## **IIoT Product End-of-Life Notice**

#### **End of Life, Last Time Buy and Replacement Announcement**

For immediately release, Advantech is announcing the End of Life (EOL) of PCA-COM232-00A1E. The relative replacing models are as below list. Customers who had purchased this Part Number either to purchase any additional rules or migrate to the new replacement models if possible before the EOL's shipment date.

### **Reason for the Change**

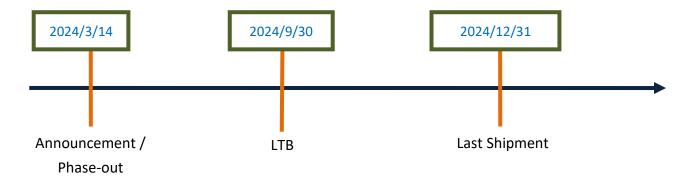
- IC F81216DG for PCA-COM232-00A1E is phased out by supplier Fintek. The replacement is PCA-COM232-00A2 which uses new IC F81216AD from Fintek.
- Please note that an BIOS update will be required for the following SBC when using PCA-COM232-00A2.

Need to update BIOS	AIMB-706, PCE-5031, PCE-5131, PCE-7131, AIIS-3411
No Need to update BIOS	AIMB-707, PCE-3032, PCE-4132, PCE-5032, PCE-5132, PCE-7132

End of Life Product	Suggest Replacement Product	Sample Available Date
PCA-COM232-00A1E	PCA-COM232-00A2	Stock available at the end of Apr
